PATENT APPLICATION
Attorney Docket No.: ANAT-1015US2
(ELL-036)

In re Application of:)
)
Frampton E. ELLIS, III)
)
U.S. Application No.: 09/527,019)
)
Filed: 03/16/2000)
)
For: Removable Rounded Midsole)
Structures and Chambers with)
Computer Controlled Processor-)
Controlled Variable Pressure)

PETITION FOR REVIEW OF DRAWING OBJECTION

FIG. 11Q

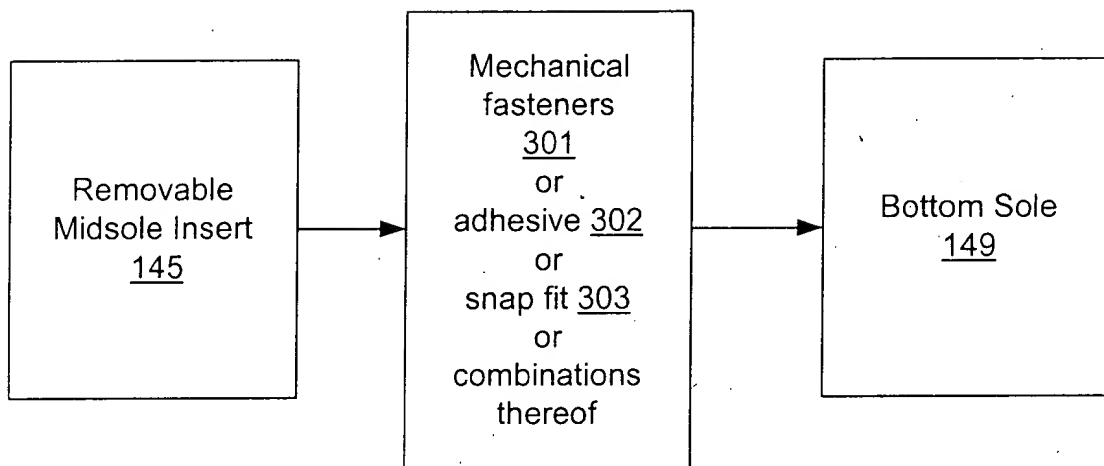
"The drawings are objected to under 37 C.F.R. §1.83(a). The drawings must show every feature of the invention specified in the claims. Therefore, the mechanical fasteners, a snap fit and 'combinations thereof', as stated in claim 4 [sic] and the computer control specifics of claim 14, must be shown or the feature(s) canceled from the claim(s). No new matter should be entered. The drawings submitted on October 5, 2001 have been received. The changes to the existing drawing have been approved but the addition [sic] of drawing 11Q, being [sic] a schematic drawing of the claimed subject matter does not clearly show what applicant is claiming, especially the 'combinations thereof'. Therefore, this drawing will not be entered."

In section 1 of the Final Rejection dated January 2, 2002, the Examiner objected to the drawings under 37 C.F.R. § 1.83(a) asserting that the drawings do not show every feature of the invention as represented in the claims. In particular, the Examiner stated that use of "mechanical fasteners, snap fits, and combinations thereof" is not clearly depicted in the new Figure 11Q - a schematic representation of "mechanical fasteners, snap fits, and combinations thereof" which was submitted by the Applicant on October 5, 2001.¹ On this basis, the Examiner has refused to enter this new Figure 11Q. The Examiner has asserted that new Figure 11Q does not depict what is claimed in Claim 4 [sic].²

Second, as clearly stated in the MPEP § 608.02, Examiner Note No. 3, if drawings are disapproved, an explanation must be provided by the Examiner. In his rejection of Figure 11Q, the Examiner has merely stated that the drawing "does not clearly show what the applicant is claiming" without providing any rationale or explanation for such a conclusion. Thus, the Examiner has not met his burden of providing an explanation of why new Figure 11Q has been disapproved. For this additional reason, the drawing objection based on claim 24 should be withdrawn.

Thirdly, there is no dispute that Figure 11Q shows the "mechanical fasteners, a snap fit, interlocking geometries, and combinations thereof" since the Examiner admitted in the Final Rejection dated January 2, 2002, that Figure 11Q is "... a schematic drawing of the claimed subject matter..." See Section 1 of the Final Rejection dated January 2, 2002. Accordingly, Figure 11Q clearly meets the requirement that it shows every feature of the subject matter claimed in claim 24.

First, this drawing objection should be withdrawn on the basis the claim 4 has been canceled without prejudice to resubmission and thus it is not necessary to show the features of canceled claim 4 in the drawings.

Finally, the Applicant respectfully disagrees with the Examiner's conclusion. As per 37 C.F.R. § 1.81(b), "Drawings may include illustrations which facilitate an understanding of the invention." Claim 24 of the present application states: "... wherein said inner shoe is releasably secured to said outer shoe by a releasable securing structure selected from the group consisting of mechanical fasteners, a snap fit, interlocking geometries, and combinations thereof." Figure 11Q uses interconnected block diagrams to clearly illustrate the attachment of the removable midsole insert 145 to the bottom sole 149 via "mechanical fasteners 301, or adhesives 302, or snap fit 303, or combinations thereof". Moreover, lines 12-20 of page 46 of the specification describe how, after the bottom sole 149 is attached, the removable midsole insert 145 may be inserted into the interior cavity of the upper 21 and be releasably secured to the top side of the bottom sole 149 by any suitable method, including mechanical fasteners, adhesives, snap-fit arrangements, reclosable compartments, interlocking geometries, or other similar structures. In consideration of the forgoing facts, Figure 11Q quite clearly depicts what is claimed in Claim 24 and what is described on page 46, lines 12-20, of the specification. Therefore, since new Figure 11Q clearly shows all of the elements claimed in claim 24 and finds basis in the specification as discussed above, the Applicant respectfully requests that Figure 11Q submitted on October 5, 2001, be entered as part of this application and that this objection to the drawings be withdrawn.
